Proposed Development of Wingecarribee
Animal Shelter + SES Facilities at
1 Bowman Road, Moss Vale, NSW

s. 4.55(2) Application

STATEMENT OF ENVIRONMENTAL EFFECTS

June 2023

Figure 2A: Change to window & glazed door frames – s.4.55 Modification

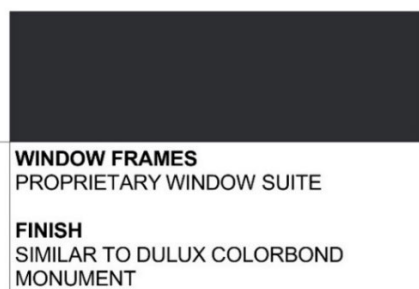
- Change of colour of window and glazed door frames from “Silver” to “Monument”. (Figures 2A & 2B)

Figure 3A: Change to section of wall on north-eastern (and south-eastern) façade – s.4.55 Modification (source: F&J Tepa)

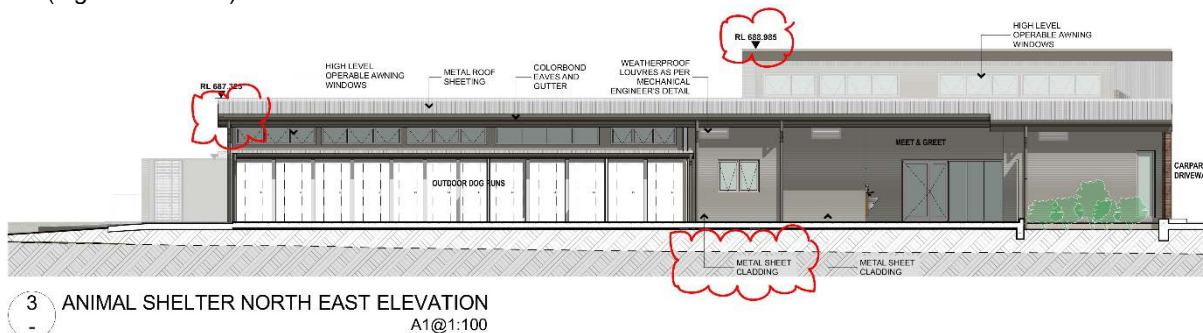
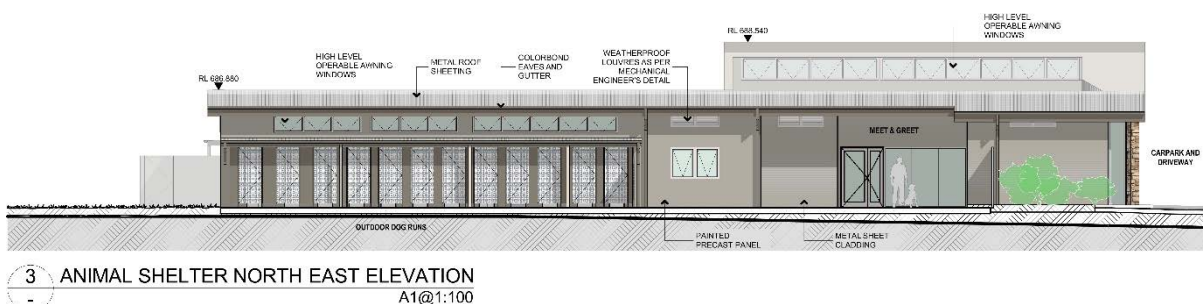
- Change to external wall sections on the north-eastern and south-eastern façades from precast concrete panel to proprietary steel wall frame and cladding, with external colour to remain the same, being colorbond “Dune”. (Figures 3A & 3B)

Figure 4A: Minor changes to internal layout of Animal Shelter facility – s.4.55 Modification (source: F&J Tepa)

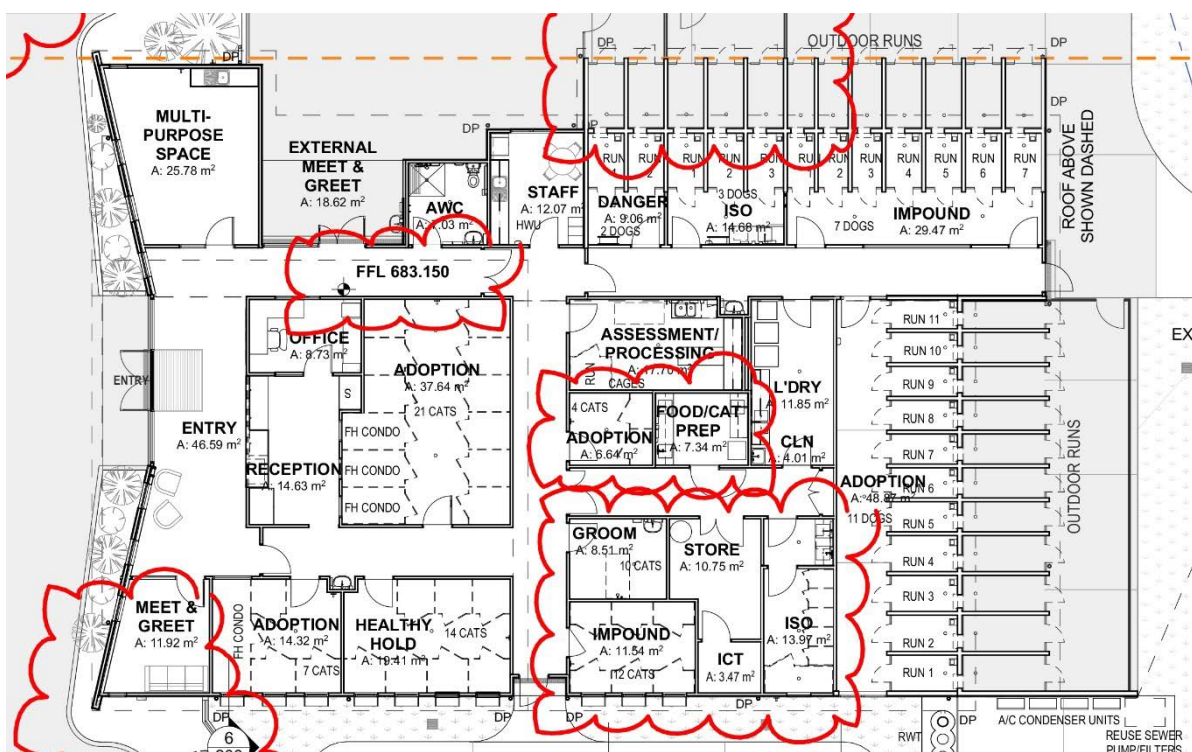
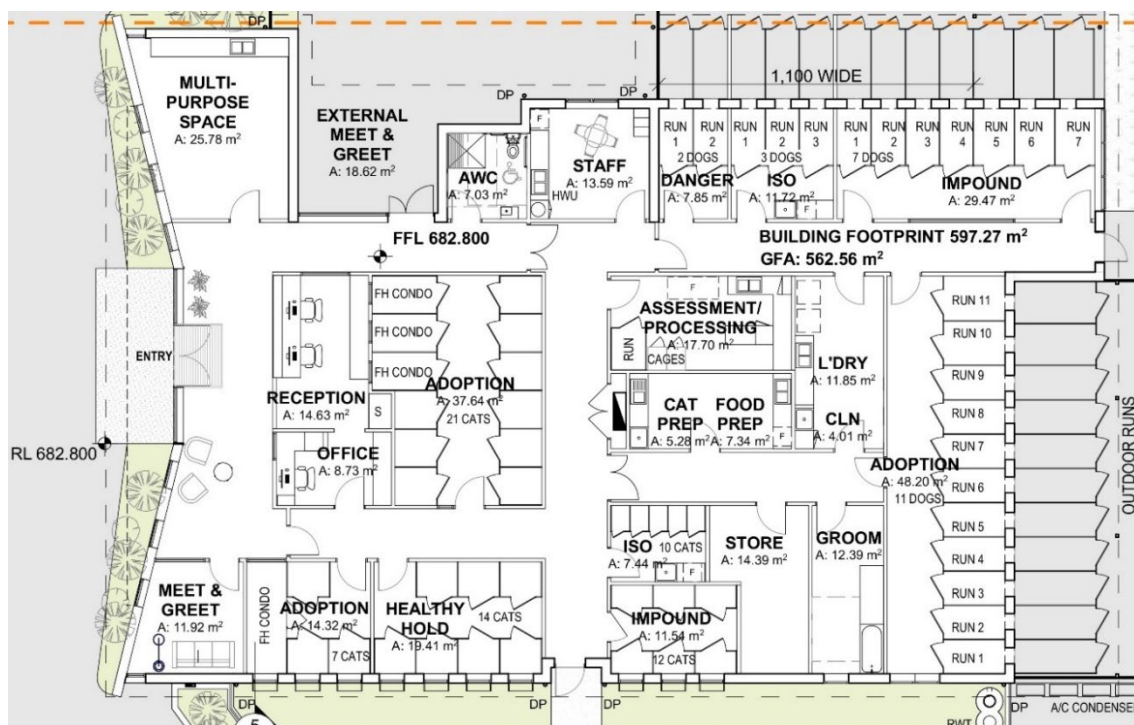
- Minor changes to internal layout of Animal Shelter facility. (*Figures 4A & 4B*)
- Increase number of cats to be housed from 65 to 68.

Figure 5A: Extension of outdoor enclosure for dangerous and isolation dogs – s.4.55 Modification (source: F&J Tepa)

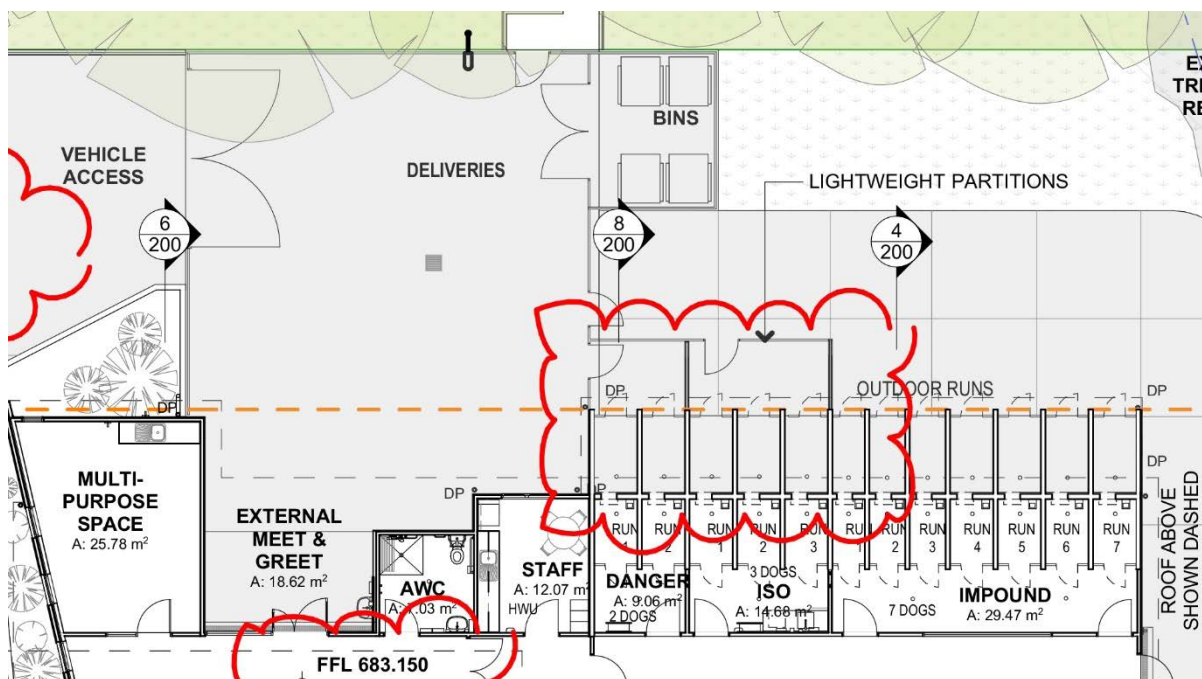
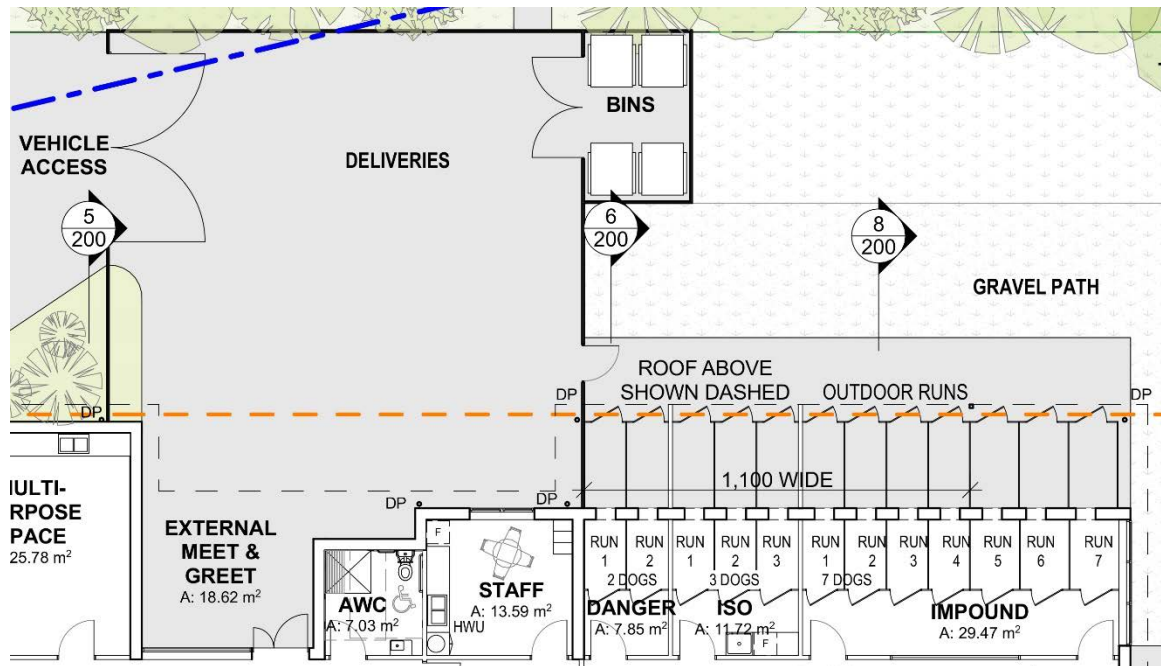
- Extension of outdoor enclosures for “Dangerous” and “Isolation Dogs”. (Figures 5A & 5B)
- Provision of light-weight solid/ opaque partitions to enclosures – for prevention of potential spread of animal disease. (Figures 6A, 6B, 7A & 7B)
- Extension of paved area to outdoor runs for dogs. (Figures 5A & 5B)

Figure 8A: Floor level of SES building lowered by 300mm and increase in height of building – s.4.55 Modification (source: F&J Tapa)

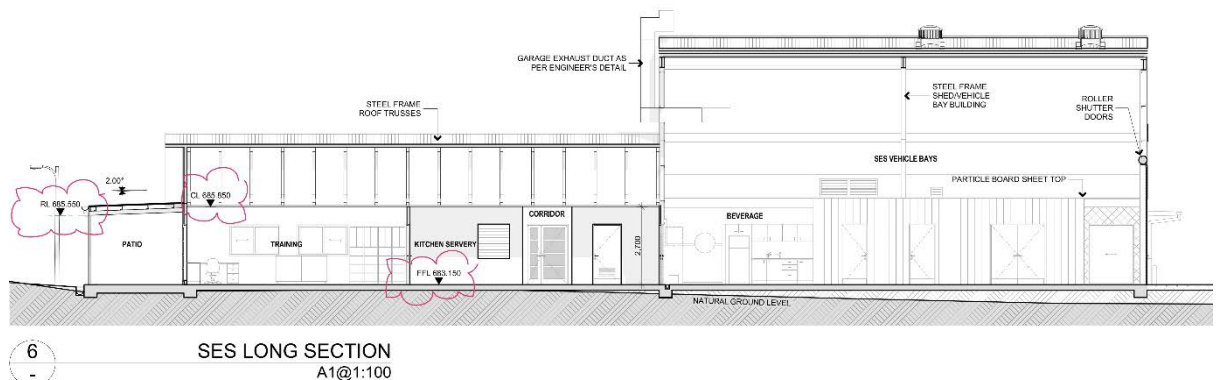
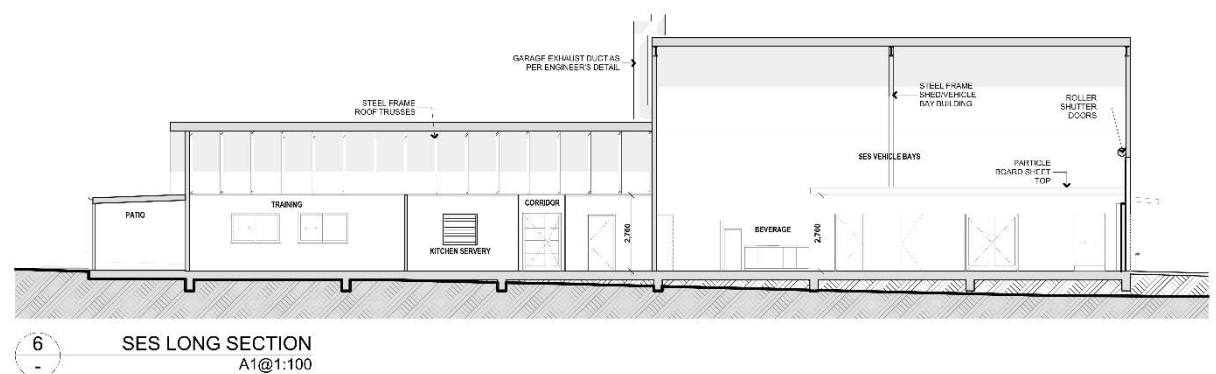
- Lowering of floor level of SES building by 250mm (from RL 683.40 to RL 683.15) due to revised stormwater design and to reduce the extent of fill under the building, resulting in both buildings having matching floor levels.
- Increase in height of the building to allow for insulation spacers to the roof structure and as result of raised floor level.

Figure 9A:
Roof Plan of relocation
of solar panels to roof –
s.4.55 Modification
(source: F&J Tapa)

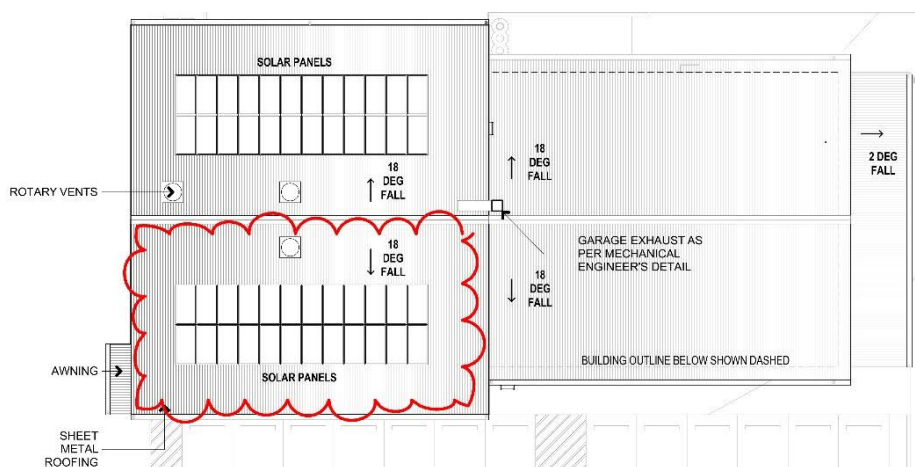
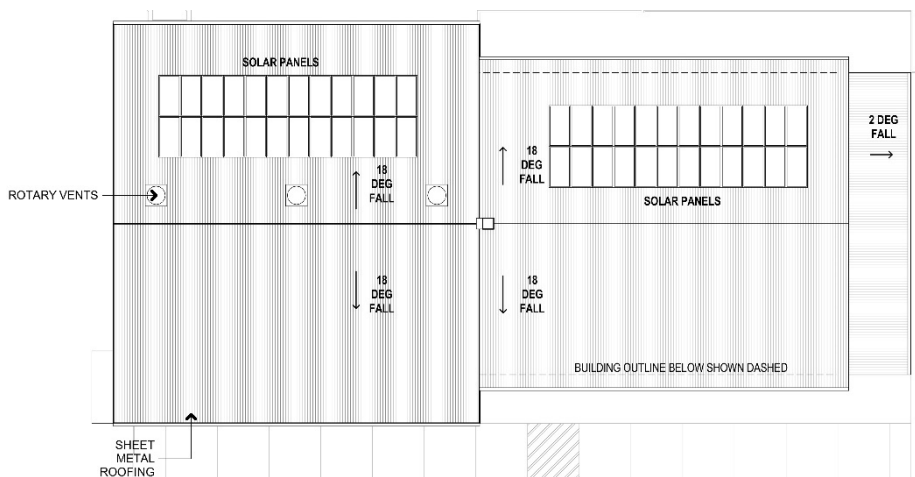
- Relocation of solar panels to roof. (*Figures 9A, 9B, 10A & 10B*)

A bank of solar/ photovoltaic panels are proposed to be relocated from the north-eastern side of the lower roof of the SES building roof to the south-western side of the roof of the SES building.

Figure 11A:
Extension of driveway
adjacent to SES building
and provision of a
balustrade – s.4.55
Modification
(source: F&J Tapa)

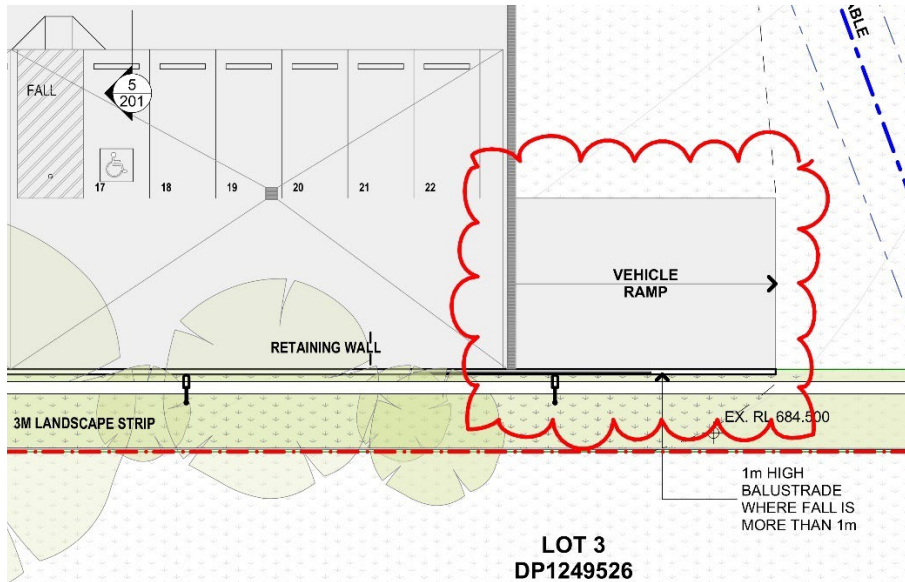
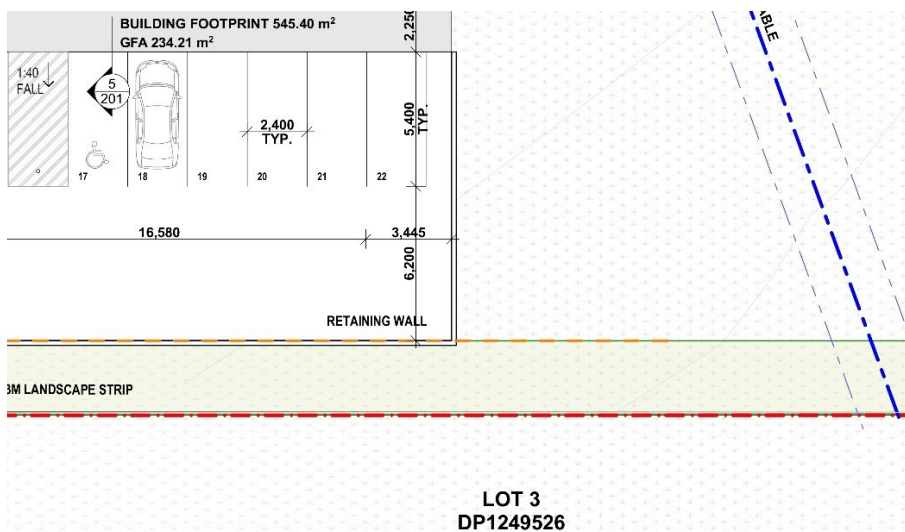
- Extension of a ramped driveway adjacent to the SES building or vehicles to access the rear grassed portion of the site.
- Provision of 1m high balustrade along the extended driveway where fall is more than 1m.

Figure 12A: Landscape amendment to planting bed at the front of the Animal Shelter building – s.4.55 Modification

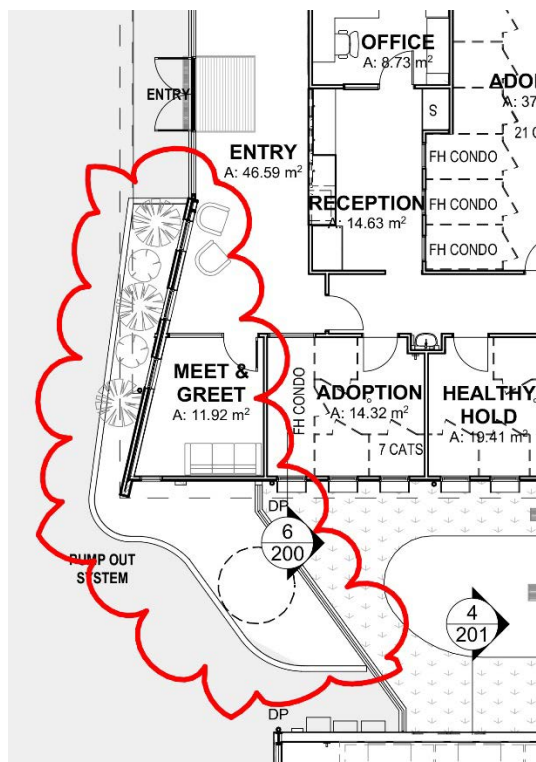
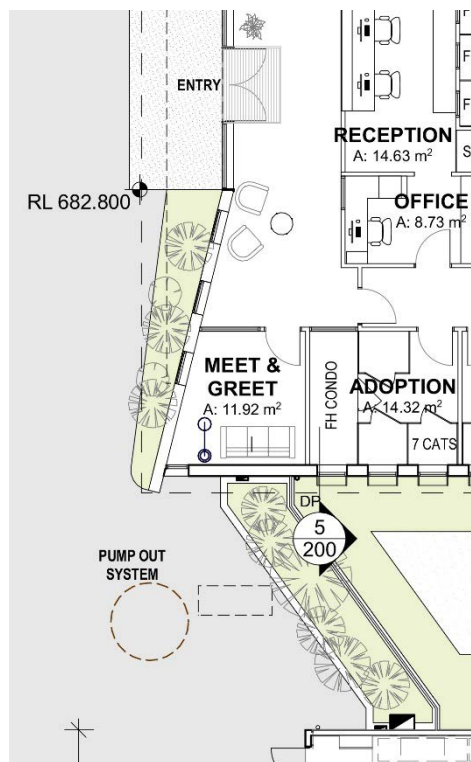
- Amendment to planting beds at the front of the Animal Shelter building. (Figures 12A & 12B)
Refer additionally to Landscape Architects' revised drawings.

Figure 13A: Fence extension at rear (SE) boundary – s.4.55 Modification (source: F&J Tapa)

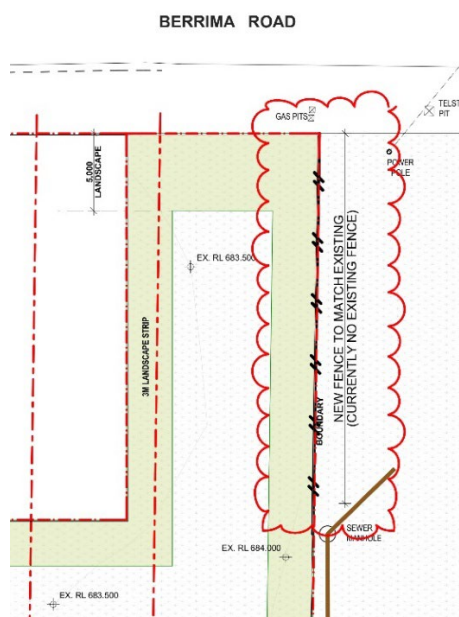
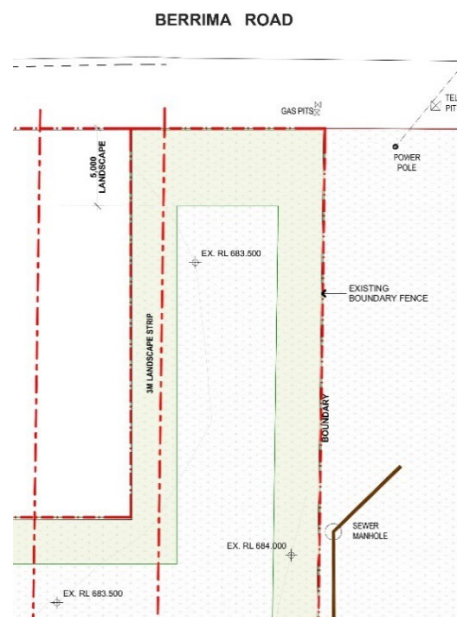
- Extension of fence along rear (south-eastern) boundary, with fence to match existing. (Figures 13A & 13B)

Figure 14A: Modifications to OSD basin – s.4.55 Modification (source: F&J Tepa)

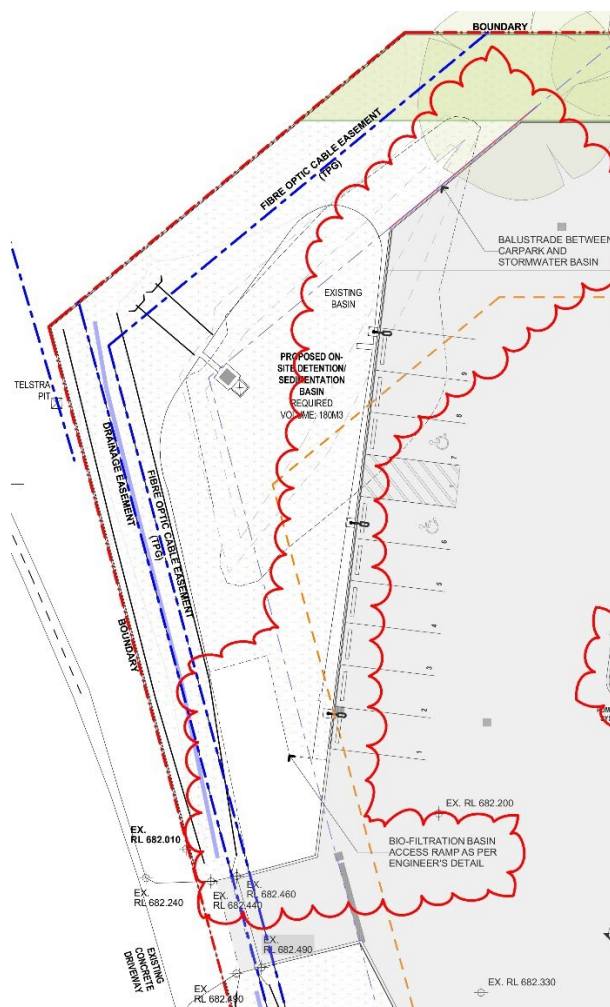
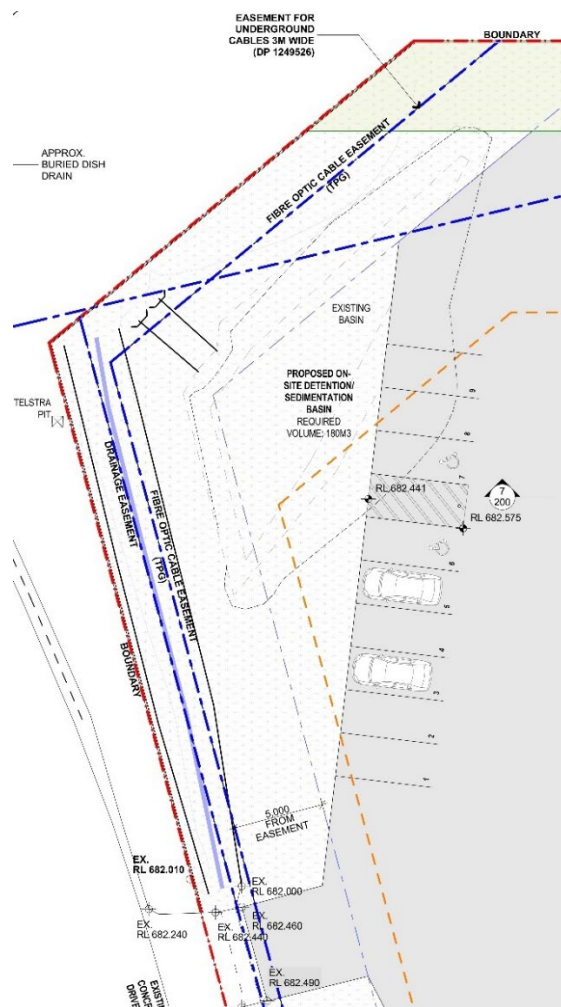
- On-site detention (OSD) basin altered to be a bio-filtration basin to better suit water catchment.
- Addition of a ramp to access the basin from car park level.
